CITY OF CODY  
PLANNING, ZONING AND ADJUSTMENT BOARD  
TUESDAY, DECEMBER 10, 2013  
CITY HALL COUNCIL CHAMBERS @ 12:00 NOON

<b>MEETING DATE:</b>	DECEMBER 10, 2013	<b>TYPE OF ACTION NEEDED</b>	
<b>AGENDA ITEM:</b>		P&Z BOARD APPROVAL:	
<b>SUBJECT:</b>	PRELIMINARY PLAT OF J & K MAJOR SUBDIVISION— A 15-LOT SUBDIVISION. SUB 2013-06	RECOMMENDATION TO COUNCIL:	X
<b>PREPARED BY:</b>	TODD STOWELL, CITY PLANNER	DISCUSSION ONLY:

# PRELIMINARY PLAT

## FOR THE J. & K. MAJOR SUBDIVISION

SHEET NUMBER  
**6**  
 OF 13 SHEETS

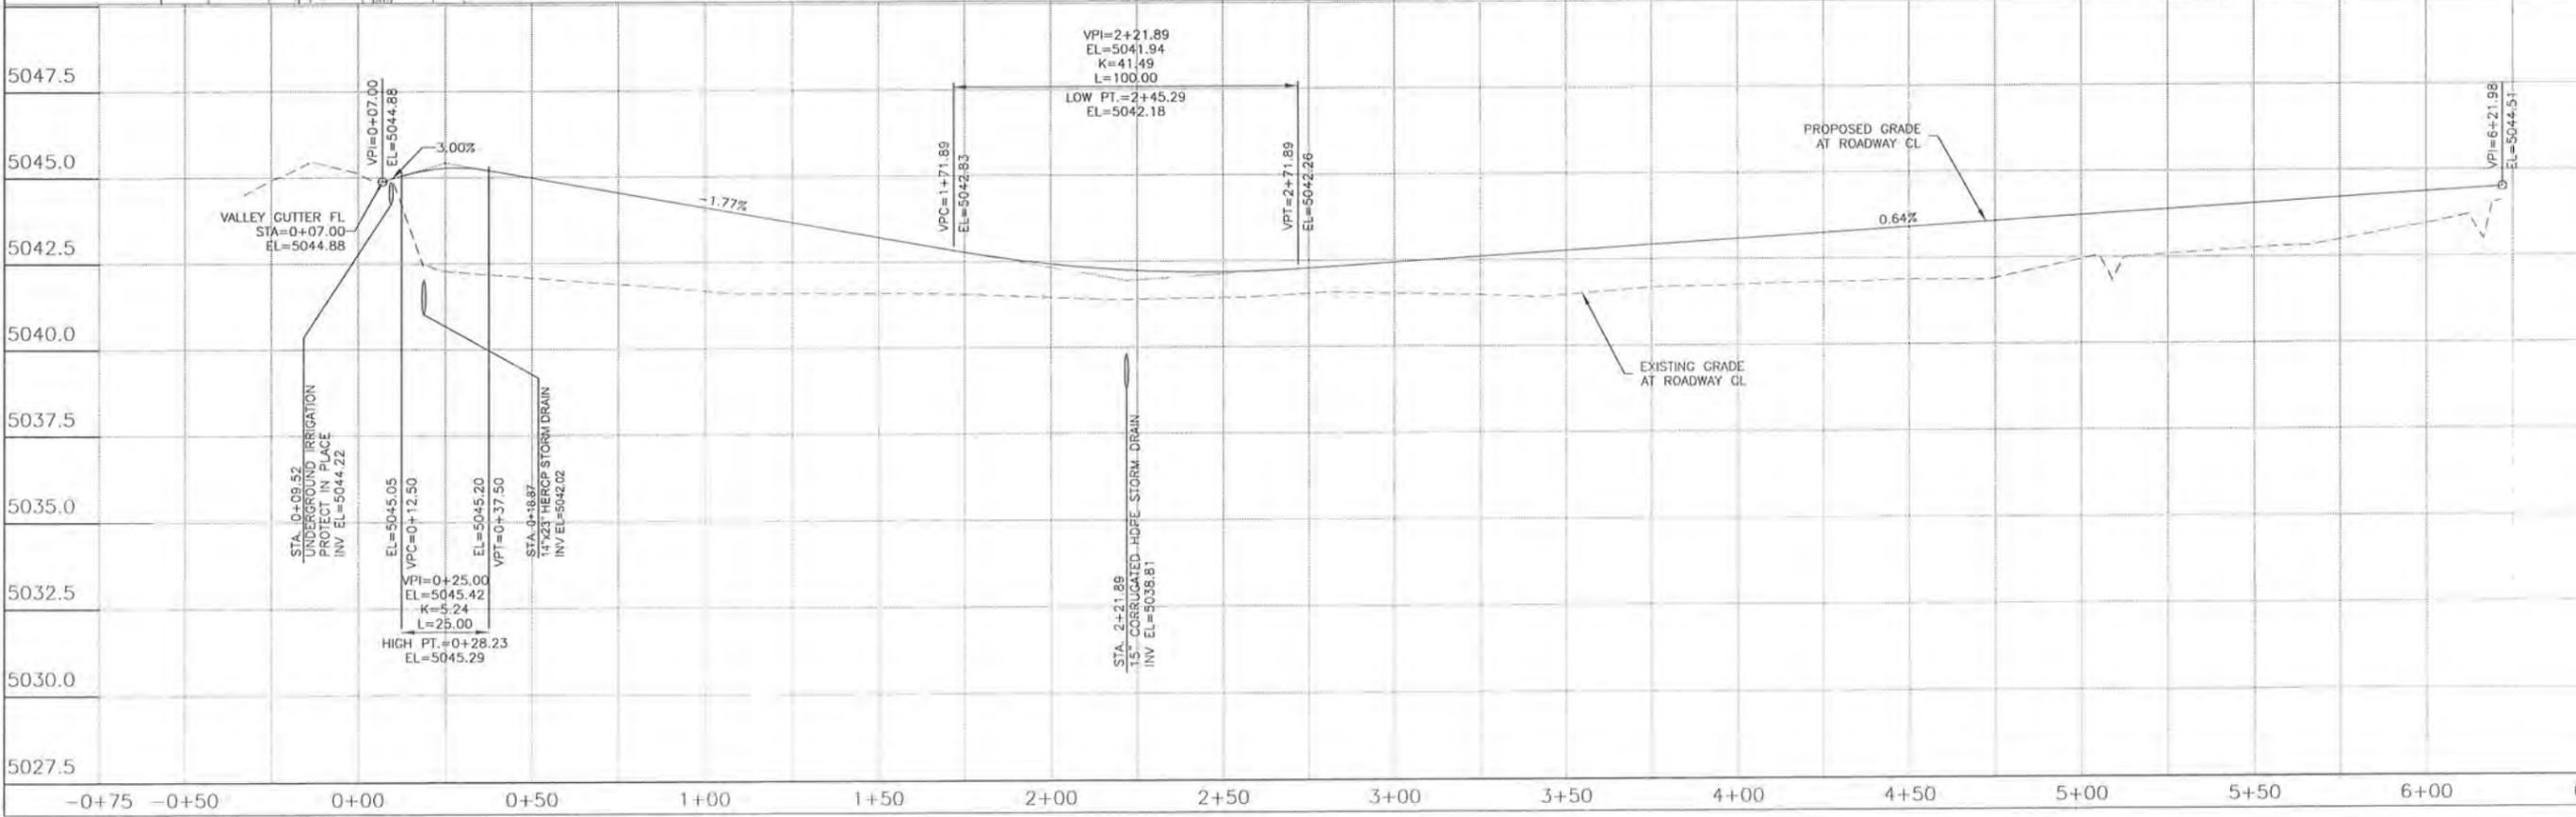
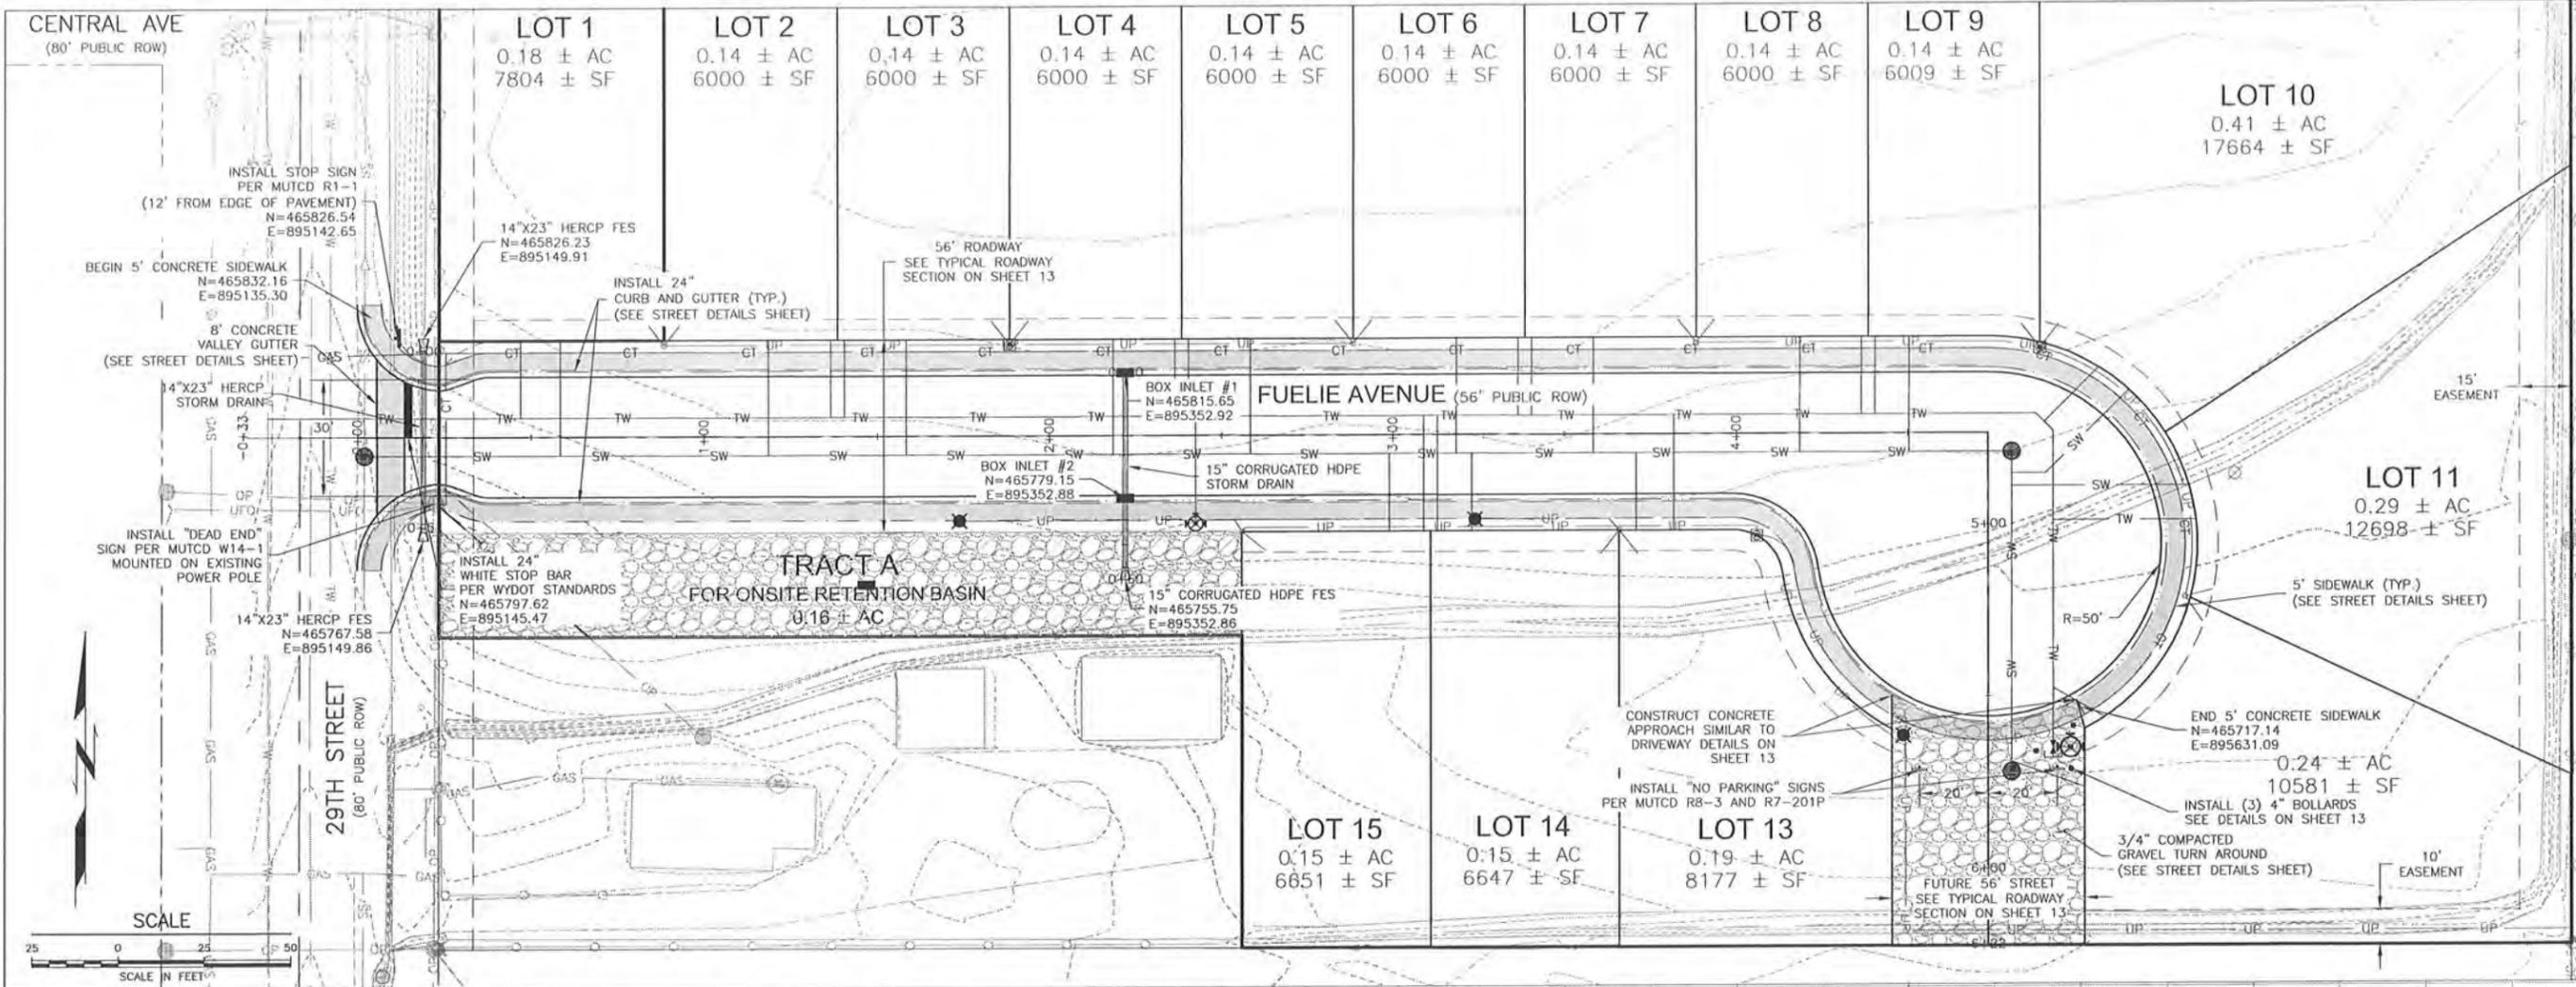
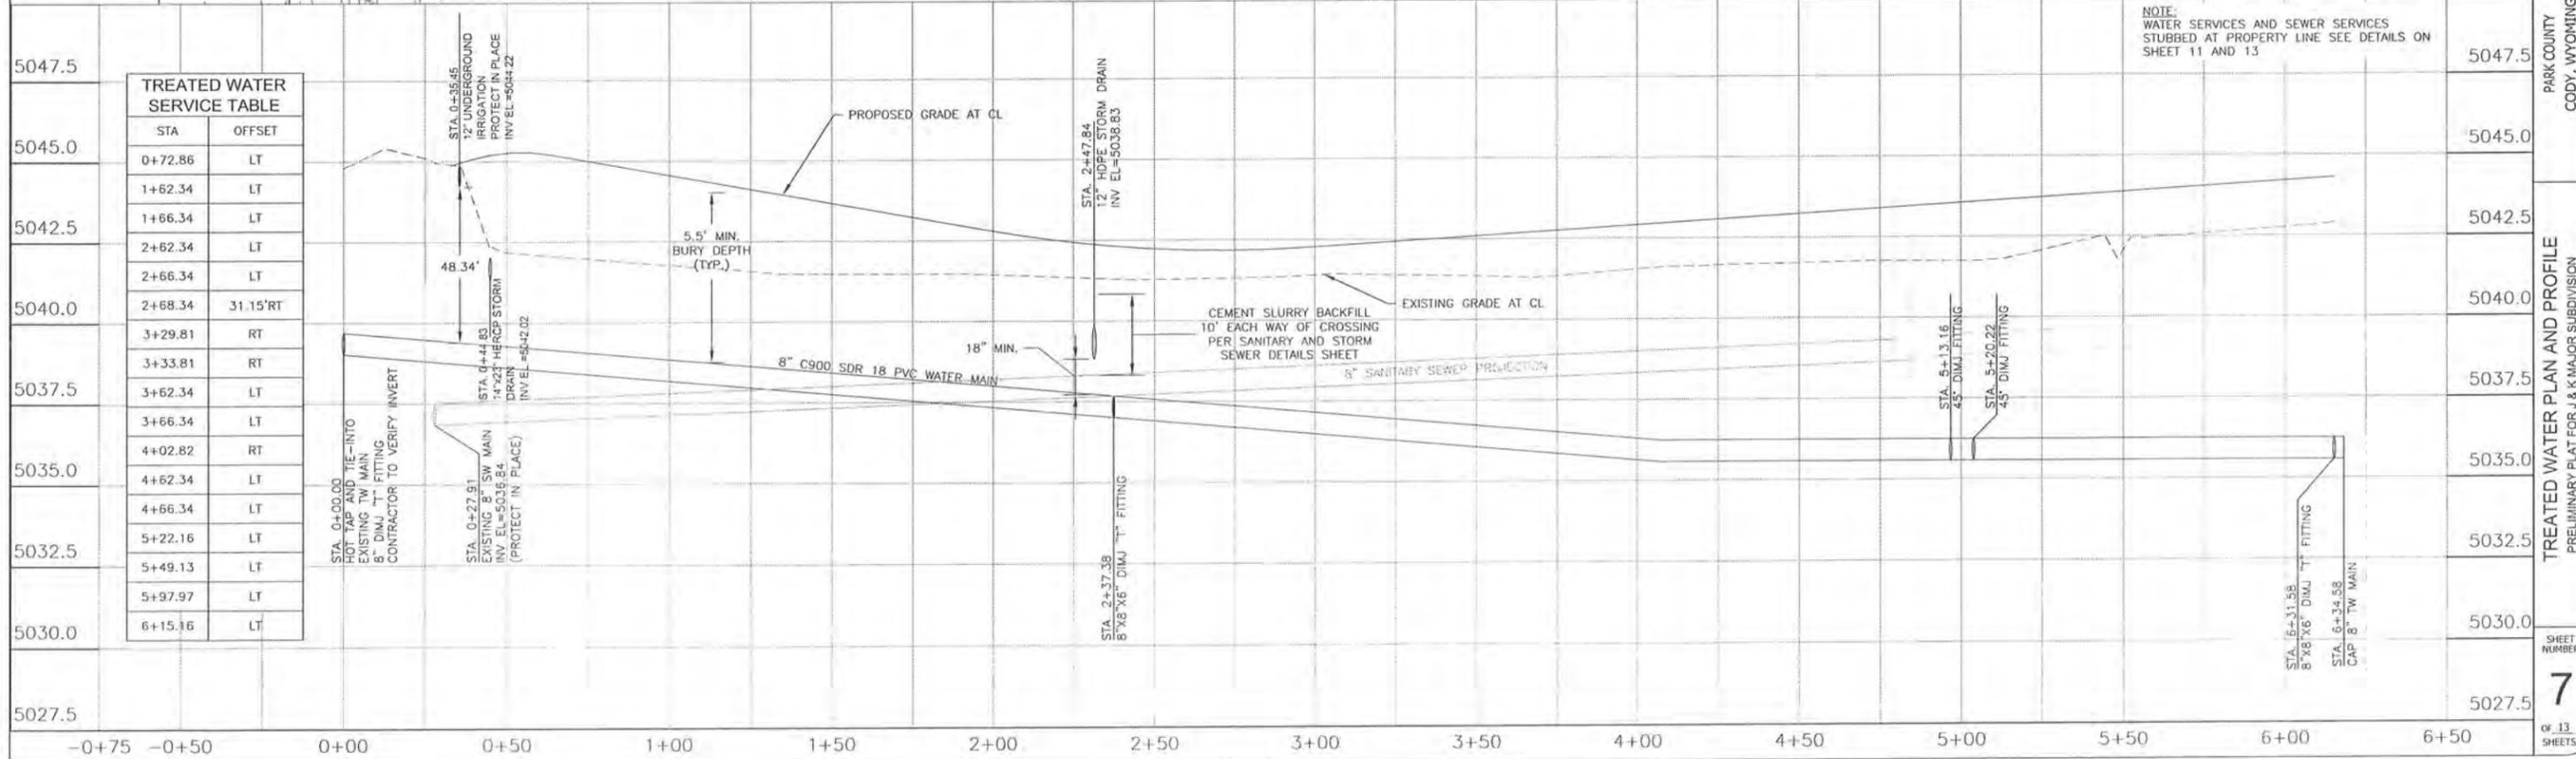
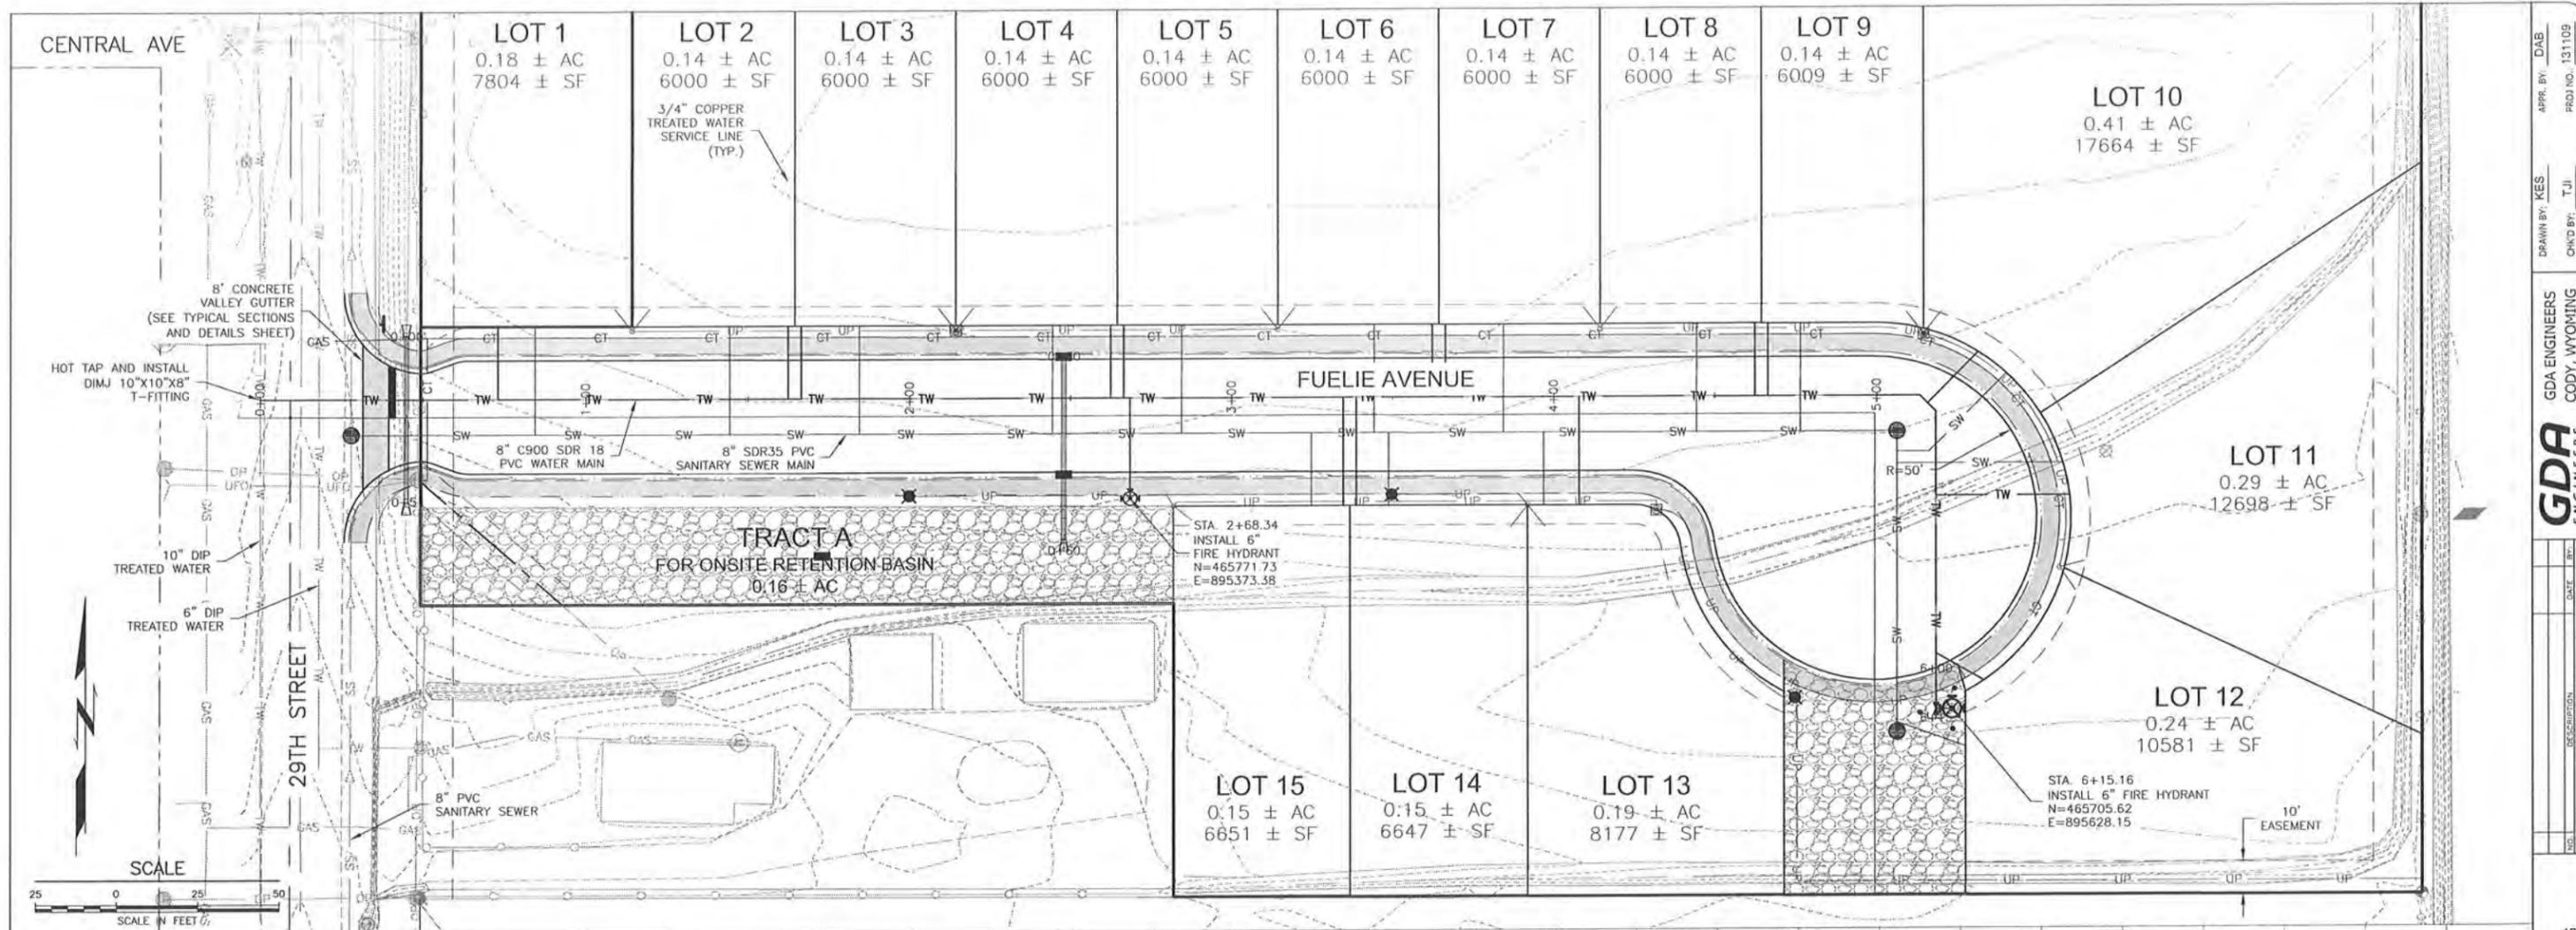
Sheet 6: Add "Dead End" or "No Outlet" signs. Add "No Parking" signs in the gravel turnaround area.

Response: Signs have been added and are per MUTCD standards.

**MANHOLE COLLAR DETAIL**  
N.T.S.

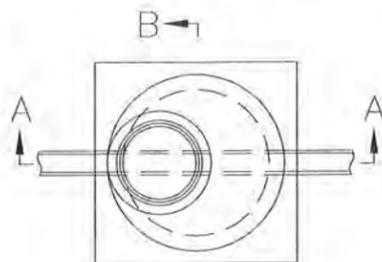
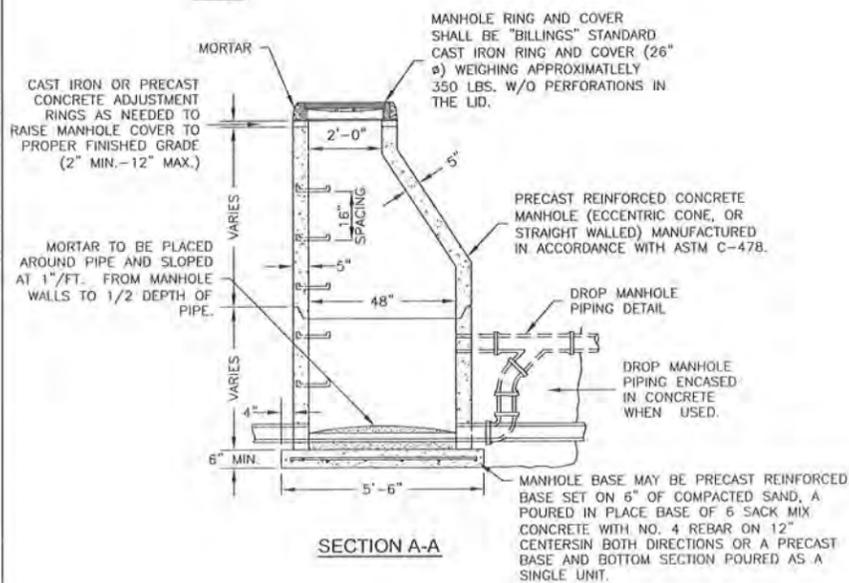
Sheet 10: Modify the manhole collar detail to refer to "all manholes"—not just in those in the paved roadways.

Response: Detail has been revised.

**TYPICAL STREET SECTION**  
N.T.S.

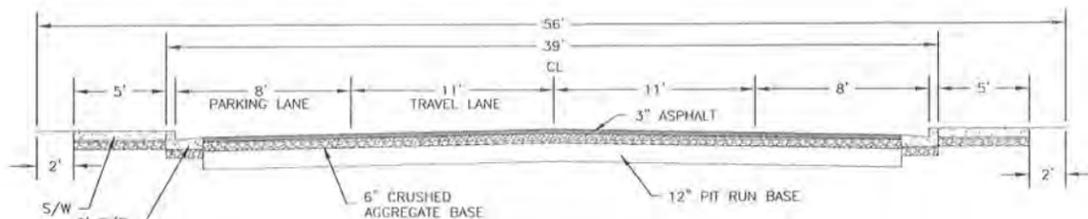
Sheet 13: Correct the typical street section detail to reflect the dimensions on the plans (39' back of curb to back of curb).

Response: Detail has been corrected to show the actual dimensions.
